Subject: ACM Highpoint PHA-HAZOP: Statement of Engineer of Record

ACM HIGHPOINT PROJECT HAZARDS & OPERABILITY STUDY

Extraction Oil & Gas

HAZOP Worksheet

EXTRACTION		
EXTRACTION INTERCHANGE WELLPAD DESIGN PIPING & INSTRUMENTATION DIAGRAM GAS LIFT SUCTION SCRUBBER		
SCALE: NTS	DRAWING NO. IN-BRM-012-65000	REV. 0

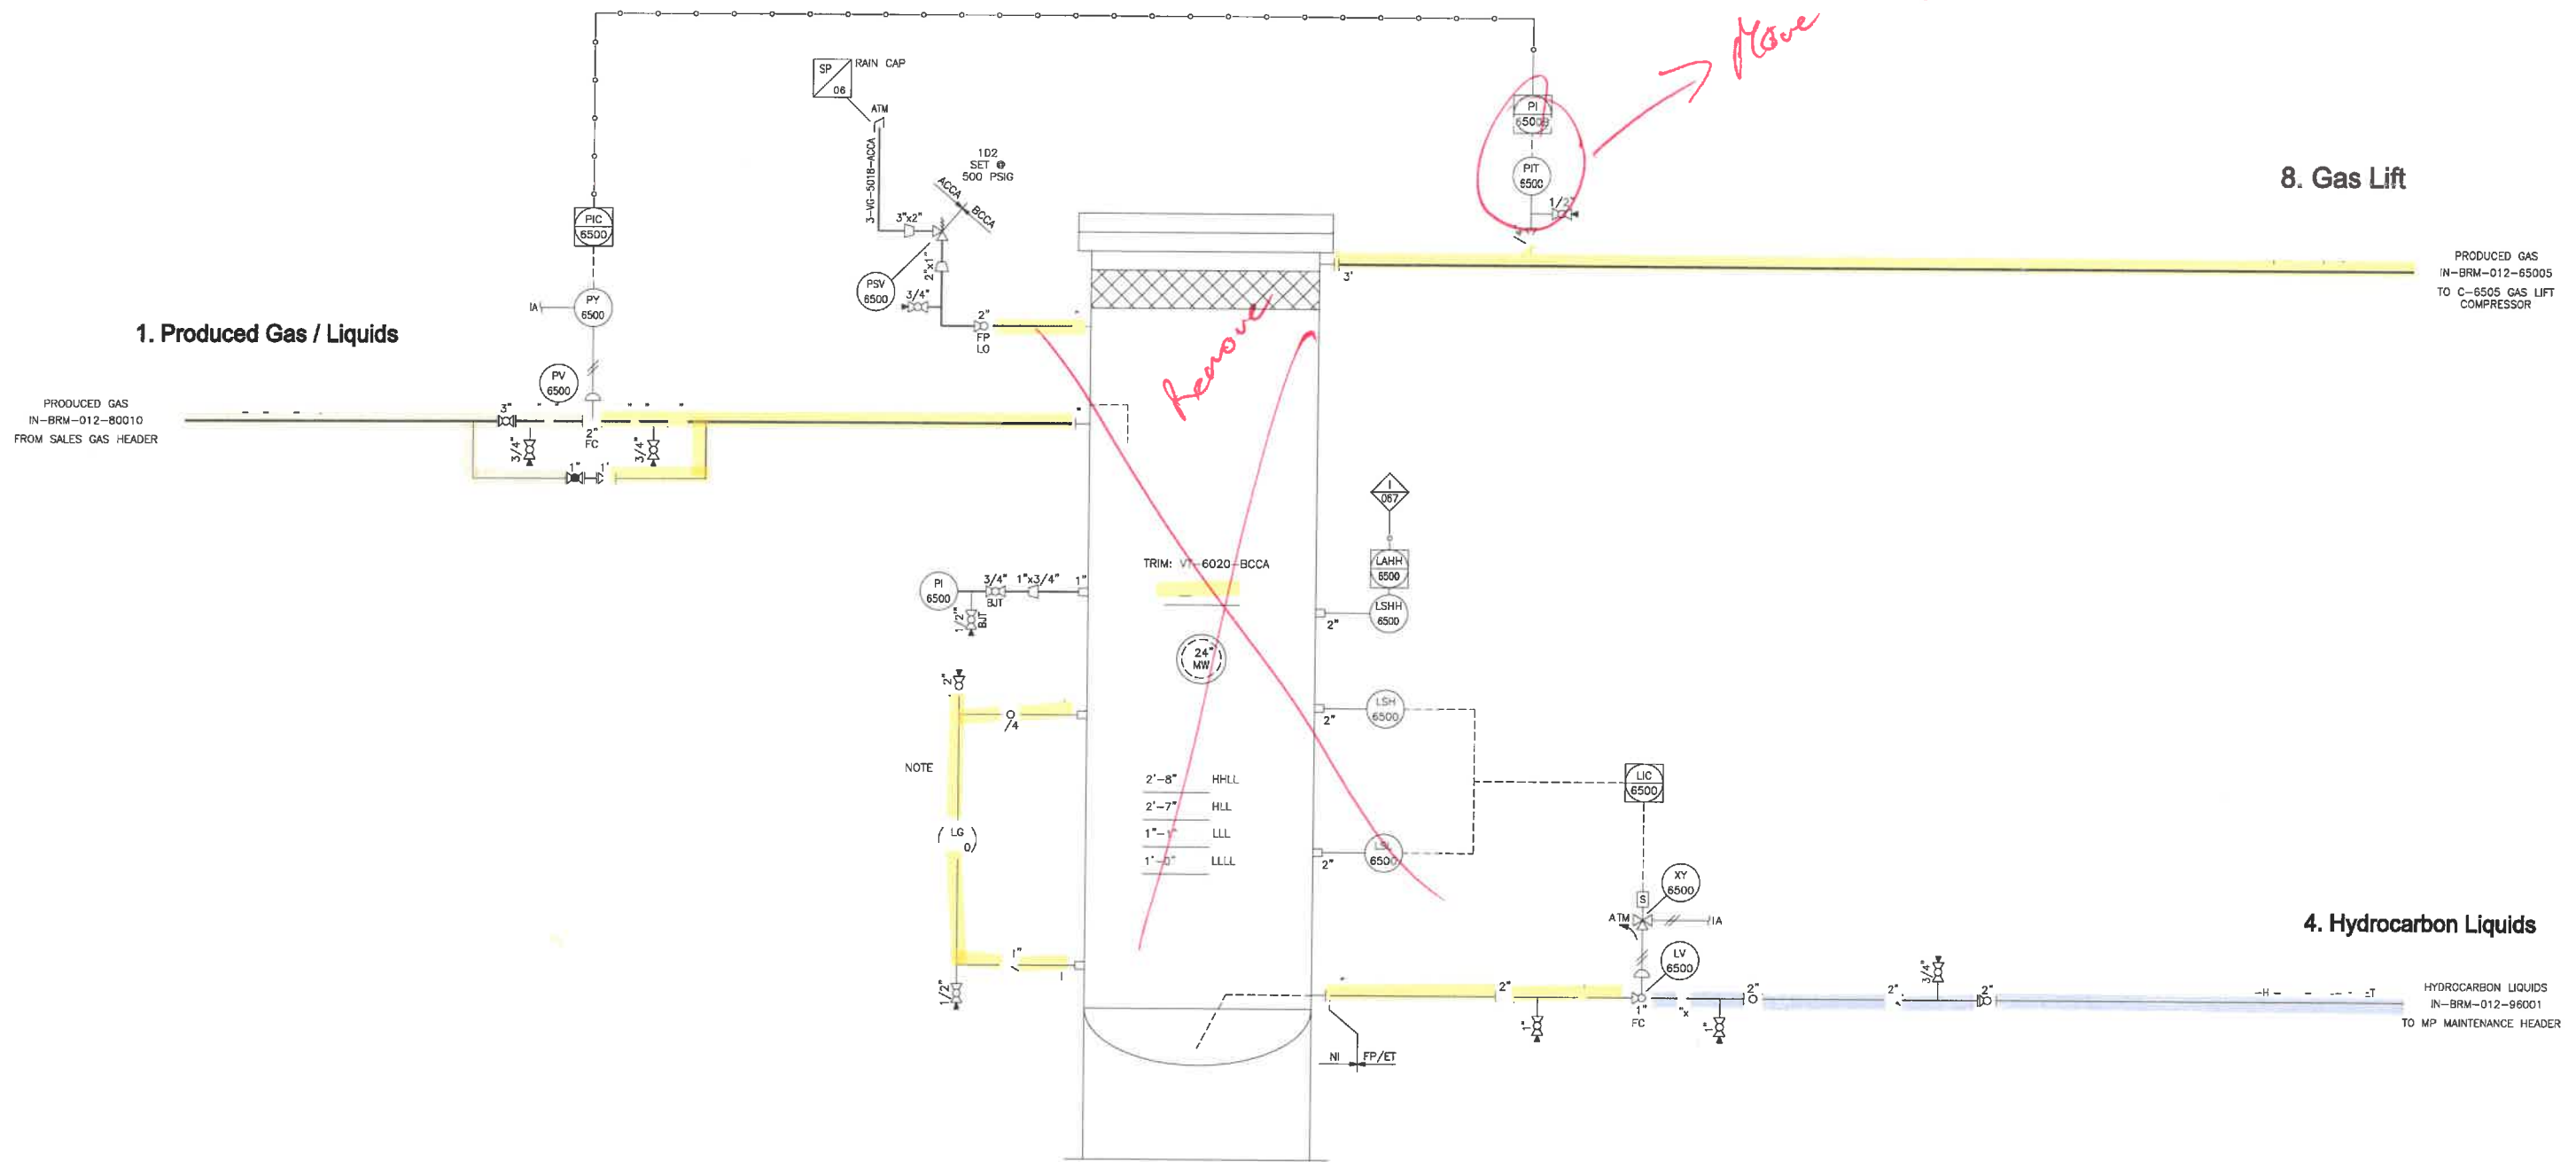
Move to Gas lift comp page
65005

CLOSED DRAIN
IN-BRM-012-50000
FROM C-5000 FLASH GAS
COMPRESSOR

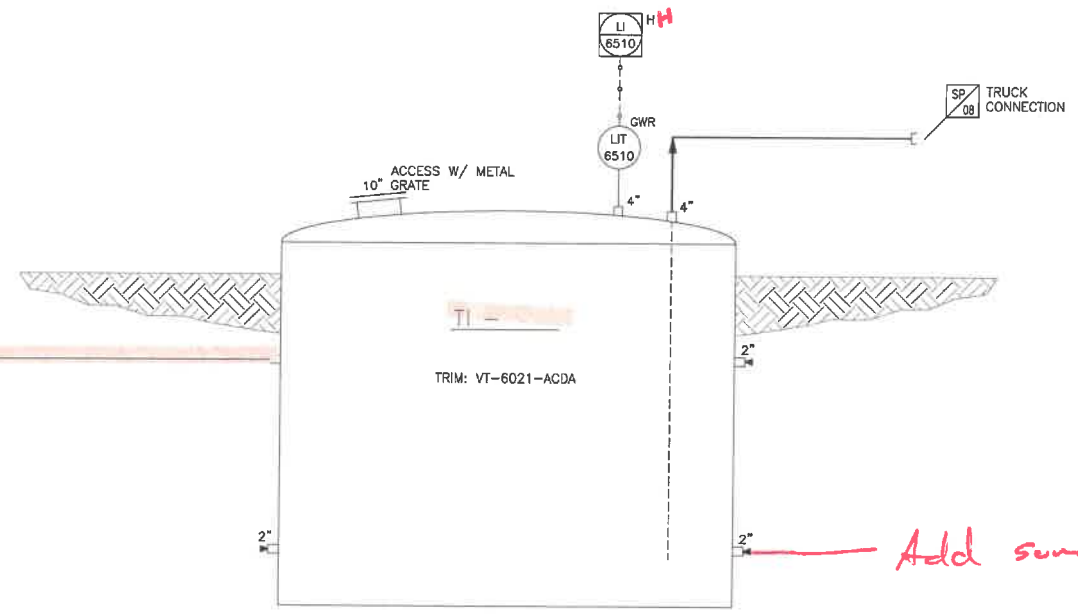
Add sump pump (manual) → Water Surge Vessel

FL-~~9670~~ 9700
EMISSIONS CONTROL DEVICE (ECD)
MANUFACTURER: BY XOG
SIZE: 144" O.D. x 40'-0" H, NOTE 3
CAPACITY: 160.4 MMBTU/HR
NOTE 5

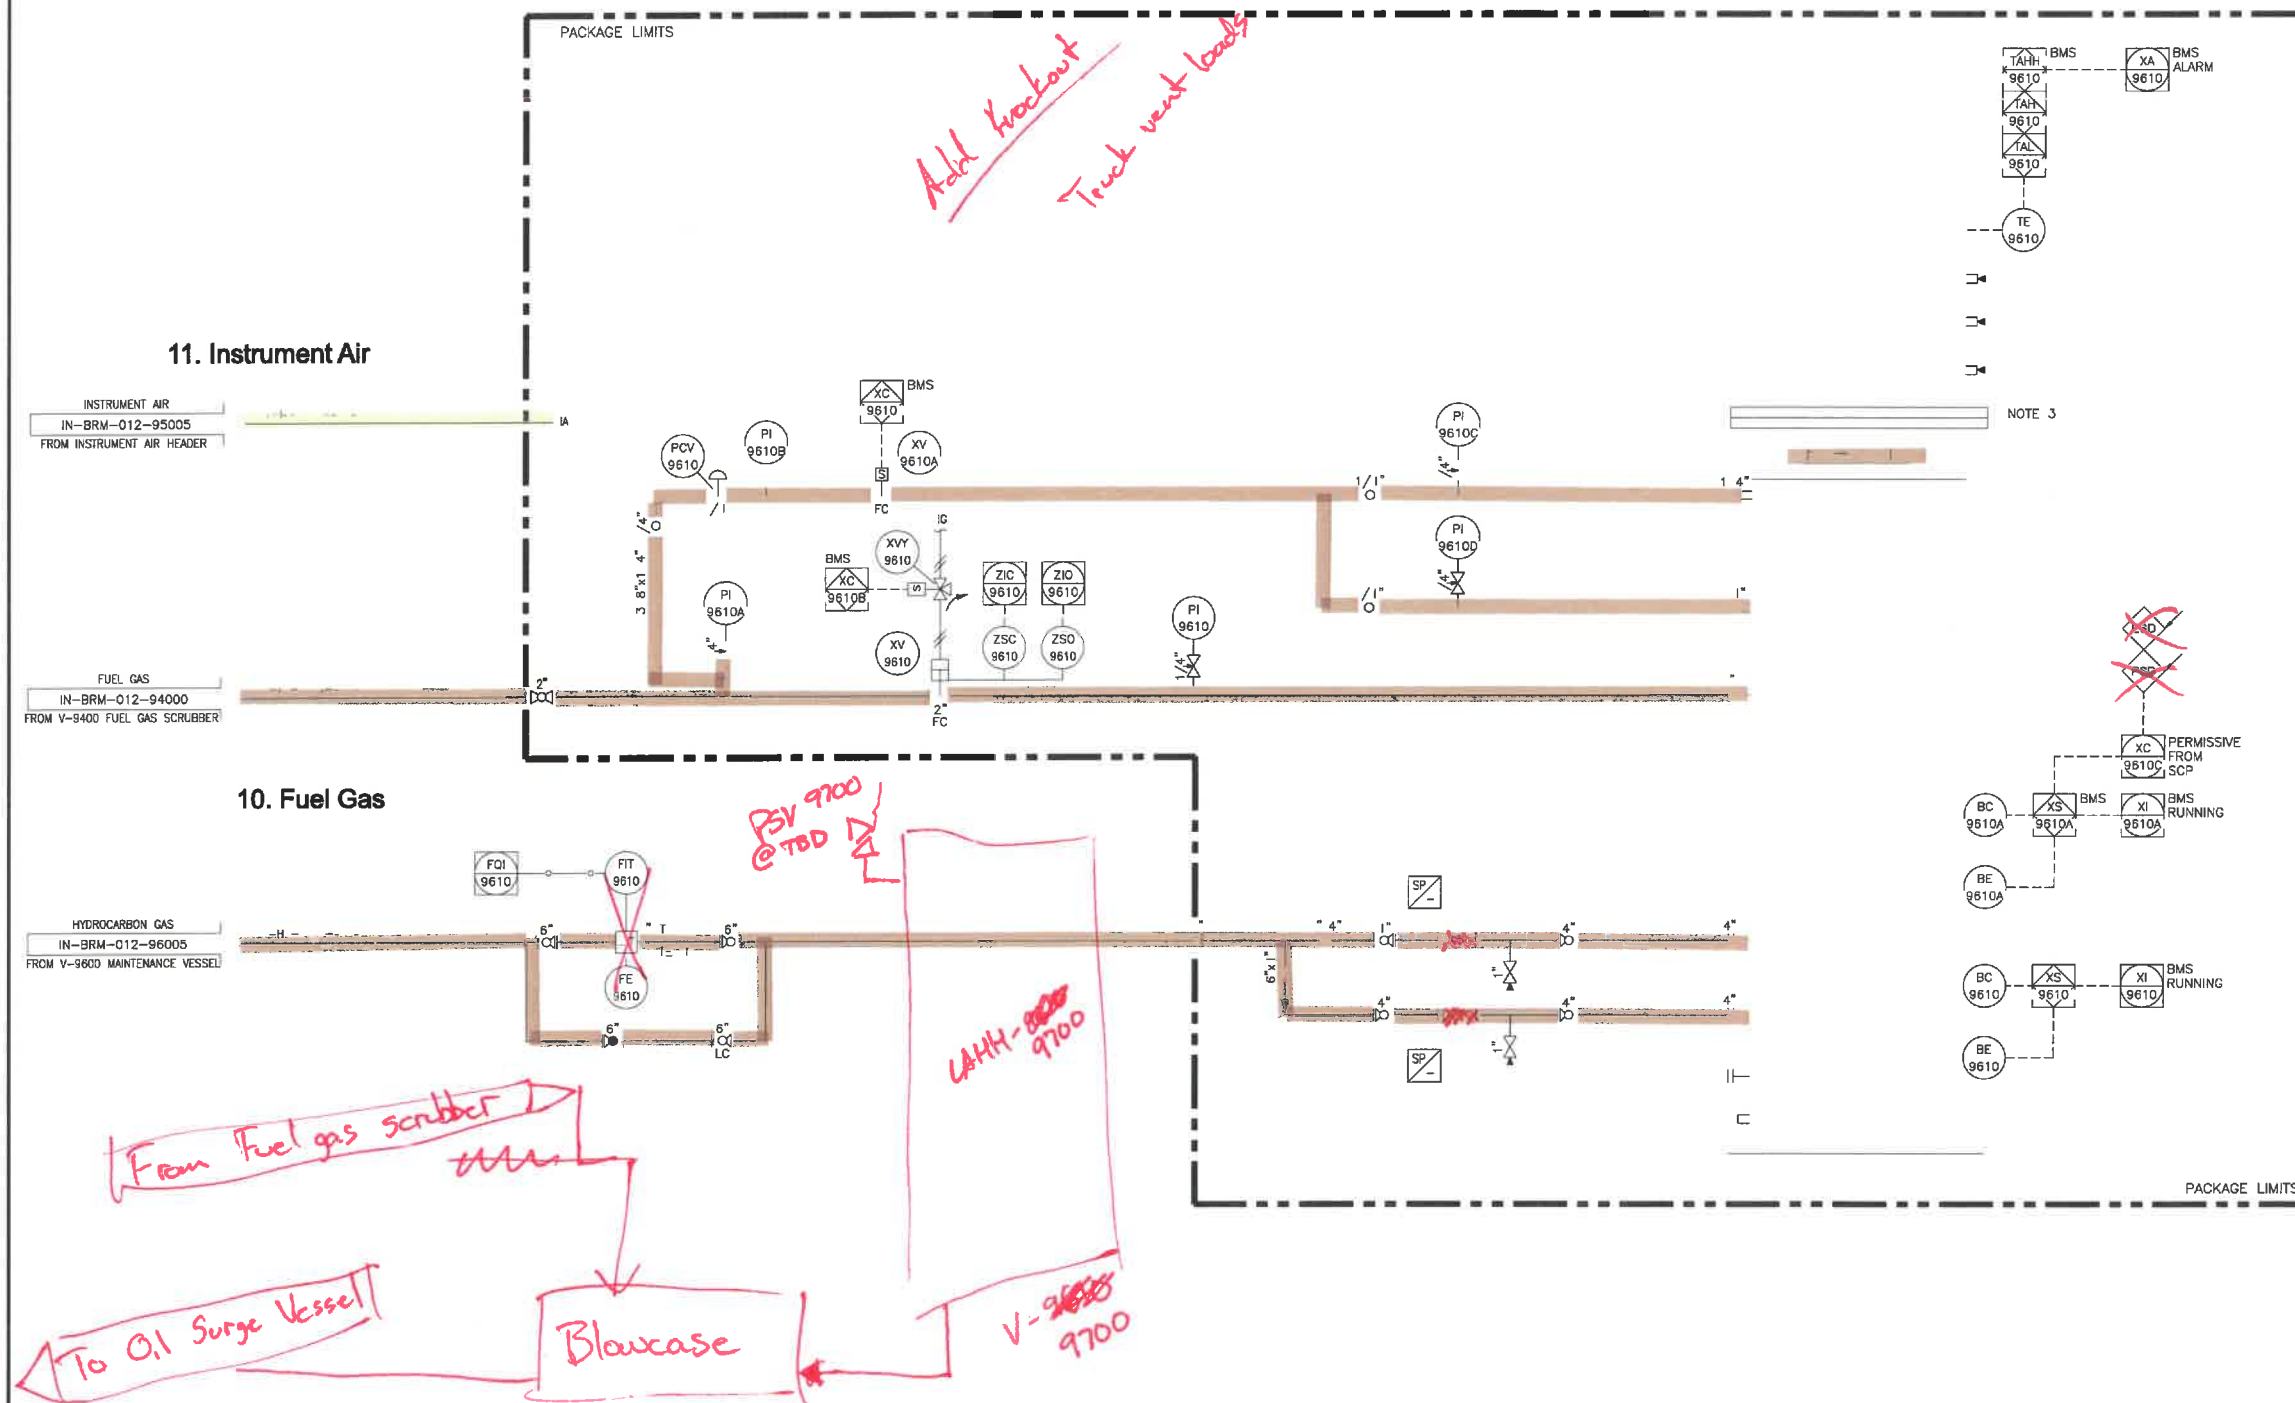
67.2. PV-9610 malfunctions open	67.2.1. See above	5	PSV-9700 set @ XXX LAHH-9700 set @ XXX, shut in V-9600 TAHH-9610 set @ XXX, shut in V-9600	3	8		74. Verify flow barrier (tips) of FL-9700

67.4. Discharge BV (V-9700) inadvertently closed	67.4.1. See above	5	PSV-9700 set @ XXX LAHH-9700 set @ XXX, shut in V-9600 TAHH-9610 set @ XXX, shut in V-9600	3	8		76. Verify flow barrier (tips) of FL-9700
